Metro Inner Development Assessment Panel Agenda

- 3.1 Lot 4 (No. 58) Mount Henry Road, Salter Point – Proposed Use Not Listed (Third-Party Digital Hoarding Sign) – DAP/25/02863

**Part B – Item 3.1 – LOT 4 (No. 58) MT HENRY ROAD, SALTER
POINT – PROPOSED USE NOT LISTED (THIRD-PARTY
DIGITAL HOARDING SIGN)**

Form 1 – Responsible Authority Report
(Regulation 12)

Screen location – Full view during day
and night

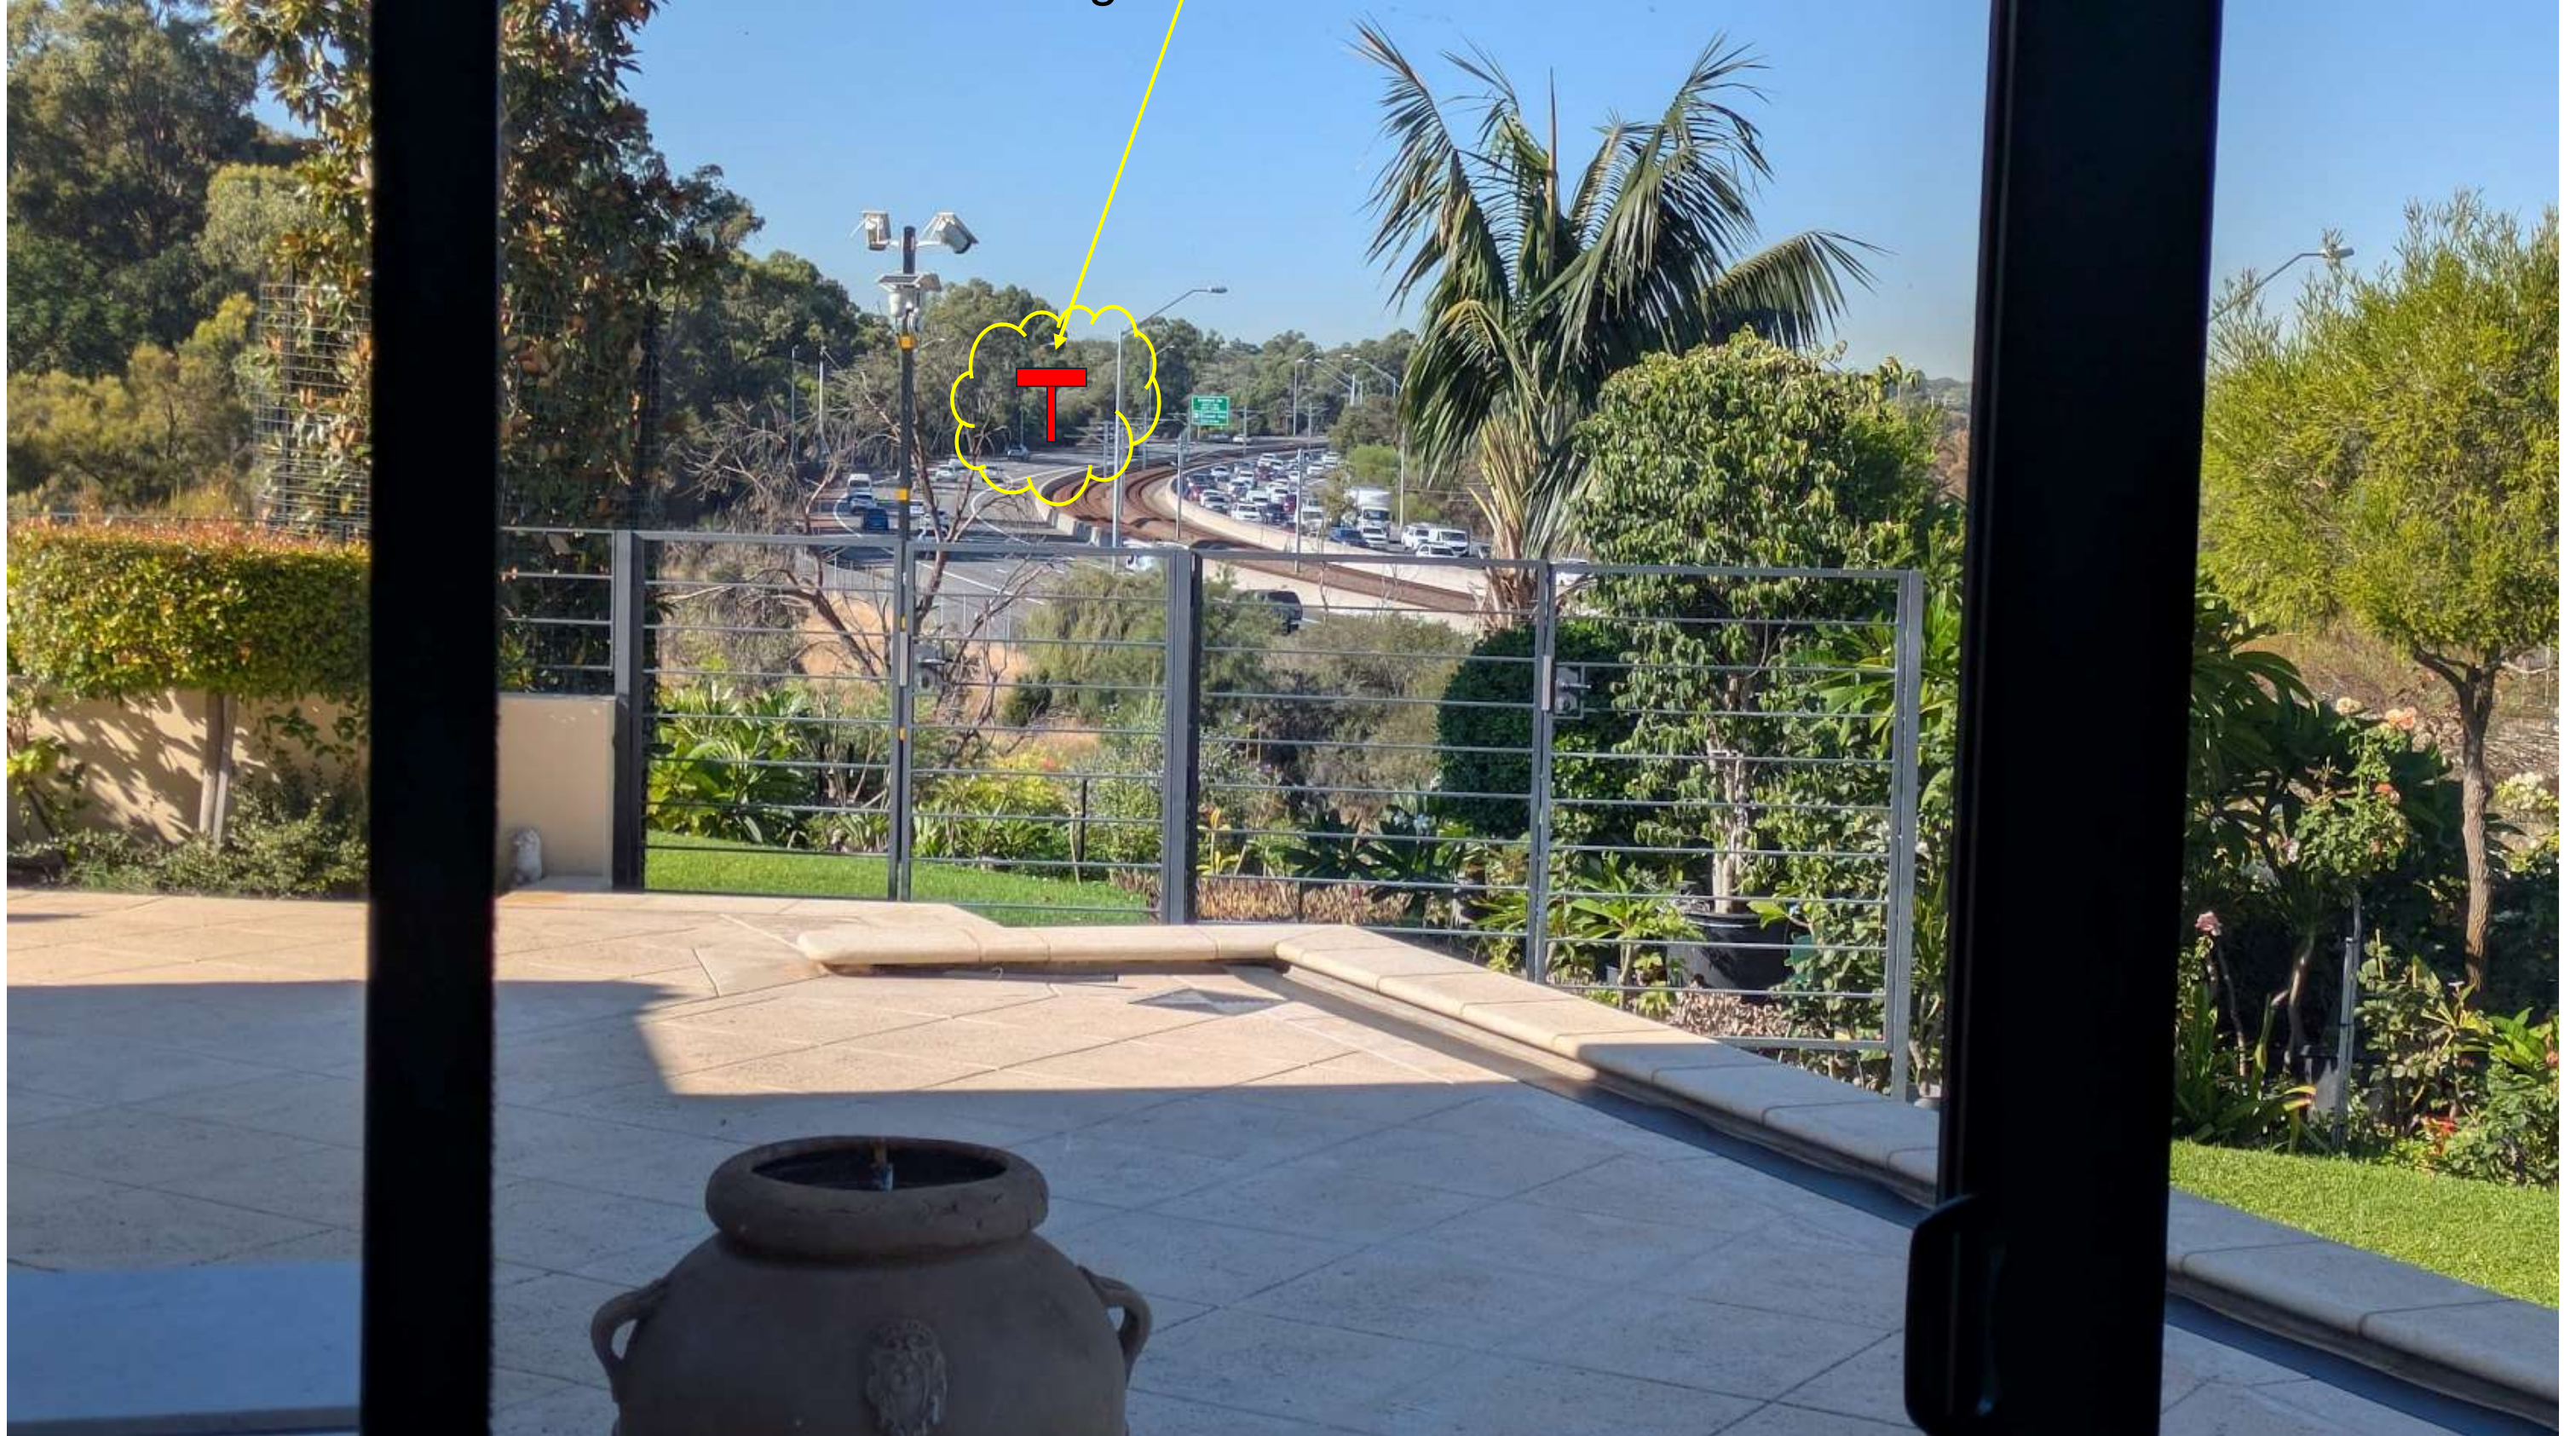
Urbis report understates the Digital Sign's (LFDS) visibility to homes on Edgewater Rd directly adjoining Aquinas. The LFDS will be wholly visible to my home at 25 Edgewater Rd that is the most impacted home by the proposal. The LFDS location has a direct sight line to my ground floor including my bedroom, bed 2, meals and living rooms. The Kwinana Fwy and Aquinas property curve and native vegetation is degraded along the sight path Comments: 1. Must be a mandatory condition for dense mature native trees (3m min height) and landscaping to be installed in strategic areas and maintained for the entire duration of the approval. This is to visually block the LFDS structure and screen to me and Edgewater Rd. Landscaping needs to be dense/high enough on Day 1 and maintained for the term so trees aren't removed. A Landscape Architect may help with species and locations based on land contours 2. In addition to landscaping, remove the north facing LFDS screen as this is the one impacting us

Figure 6 Viewshed Analysis

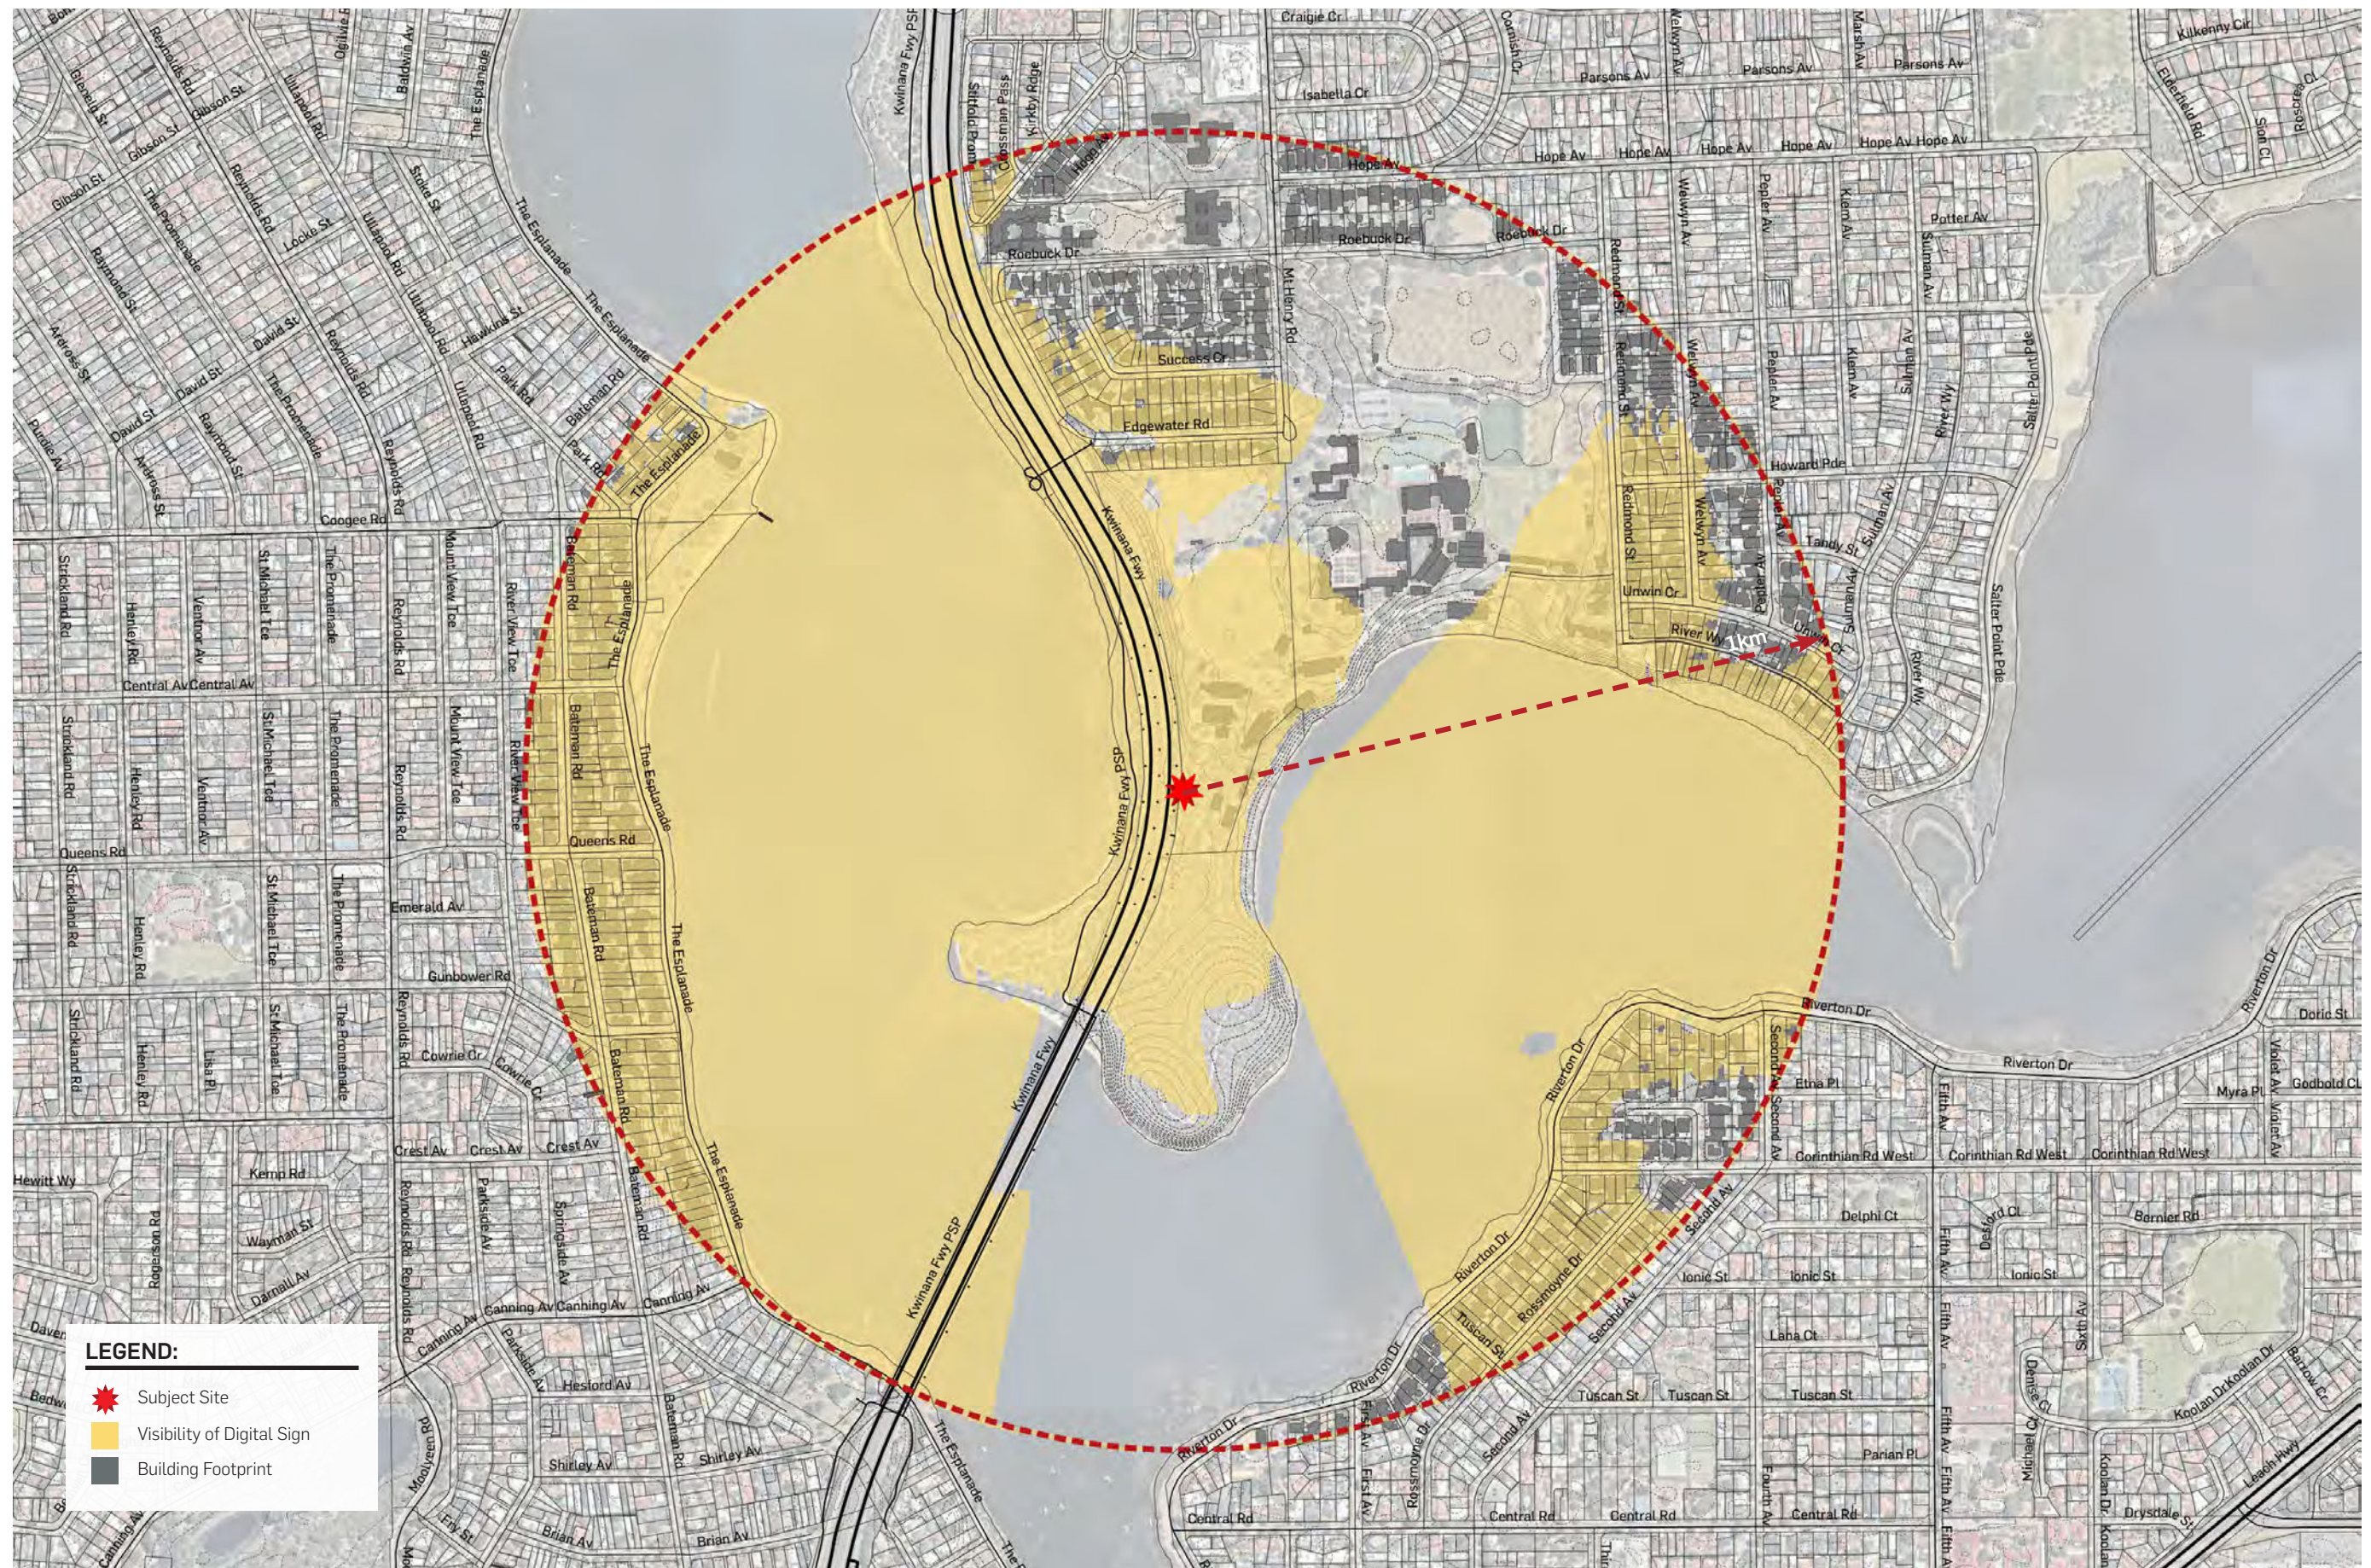
In accordance with Figure 4 (Viewshed Analysis) of Appendix D of the Urbis Development Application, I will be directly impacted by the proposed digital sign, as my home (at 40 River Way, Salter Point) lies within the yellow highlighted portion of the circle shown on that Figure. In addition, many other homes will likewise be affected (I estimate over 100). The impact will be most detrimental at night, since a LED/backlight sign is proposed, and particularly if it is intended to be run 24 hours each day/every day. Furthermore, the proposed sign contravenes Local Planning Policy 7.1 as set out in section 5.3 of the Development Application (albeit that it appears that Urbis consider it otherwise). That is, it is larger and higher than the requirements, it is two signs rather than one, it contains third party content, it does adversely impact neighboring sites and surrounding areas (as explained above), it does adversely detract from the amenity and character of the locality.
